**Staff Analysis of a Proposed Amendment to the
Dane County Water Quality Plan, Revising the Environmental
Corridors of the Central Urban Service Area
in the City of Madison**

Map 4 – Proposed Site / Stormwater Management Plan

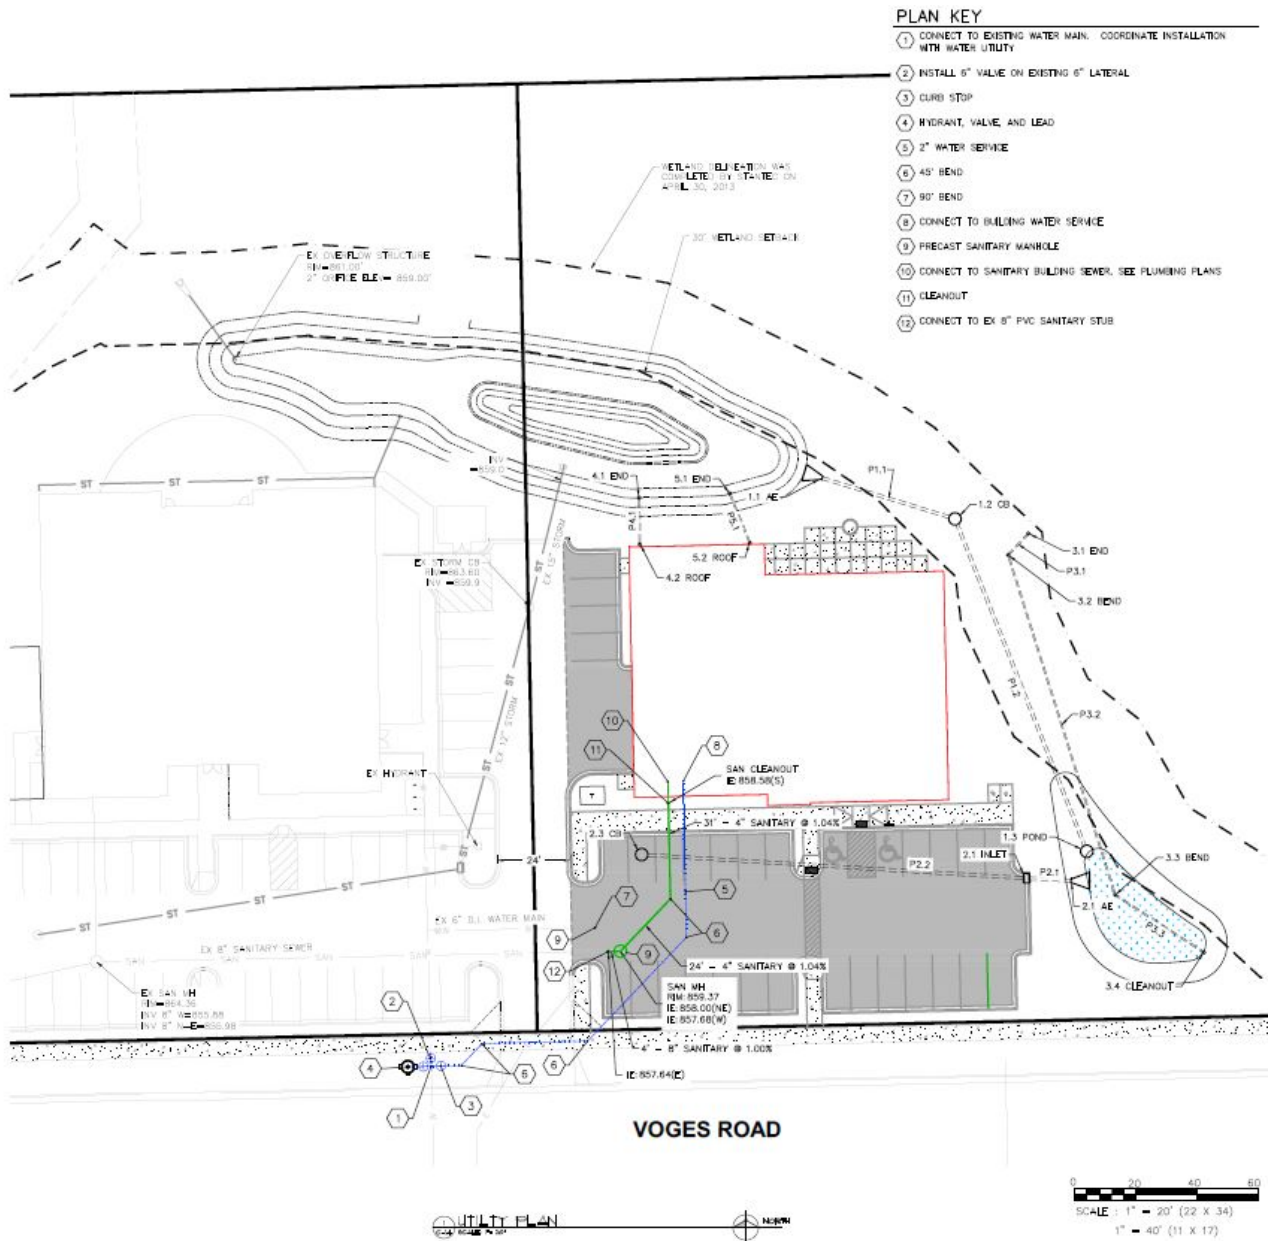
In March 2018, the phase 2 proposed project was submitted for CARPC consideration under the same assumptions as phase 1 regarding wetland setbacks and infiltration requirements. Of the 2.57 acre parcel, 0.95 acres was proposed to be disturbed (see Map 4) with portions of the proposed building, rear patio, and bioretention facility being within the 75-foot wetland buffer but outside of the 30-foot no grading zone. Restorative grading is proposed to be conducted to within approximately 5 feet of the wetland edge.

In most cases, a minimum five foot grading setback is being provided from the delineated wetland boundary, which is less than CARPC's adopted policy and criteria of 30 feet. Erosion control measures including silt fence, sediment traps, and erosion mat are proposed to control sediment during construction.

The purpose of a vegetated buffer is to provide water quality and wildlife protection functions. The proposed vegetated buffer width on the west side of the wetland of 30 to 75 feet, with an average width of approximately 60 feet, is sufficient to provide sediment and phosphorus removal. In addition, the proposed stormwater management facilities will provide additional stormwater management functions for the site. So the proposed buffer width reduction should not have a negative effect on water quality. Since the existing wetland is considered a less susceptible wetland, NR 151 only requires protective areas be established that are ten percent of the average wetland width but no less than 10 feet or greater than 30 feet. Therefore, the 60 foot average buffer width is still more protective than the standard in NR 151.

The purpose of the 30 foot no grading setback is to protect the wetland from sedimentation during construction. Effectively implemented erosion control practices can provide the same or a higher level of protection. Neither the City of Madison nor Dane County have a requirement for a grading setback from wetlands.

A better alternative to the traditional asphalt paving for the parking lot and concrete for the north patio is the use of permeable pavement. Permeable pavement reduces runoff and provides pollutant removal as well as reduces the need for winter plowing. Porous asphalt and concrete have been used successfully in the City of Madison and the University at multiple locations.

1. Submit a revised site plan for CARPC review maintaining a minimum 75-foot parking lot setback from the delineated wetland edge in accordance with the City's application for this environmental corridor amendment.
2. Require the provision of a level spreader or similar practice to spread the flow of water discharging toward the wetland.
3. Require that the vegetated buffer be maintained in dense native vegetation at a height of at least 6 inches.

1. Consider requiring/encouraging the use of permeable pavement for the north patio and parking surfaces.
2. Evaluate and improve the process for reviewing Environmental Corridors and other Water Quality Plan conditions of approval as part of the City's internal development review.
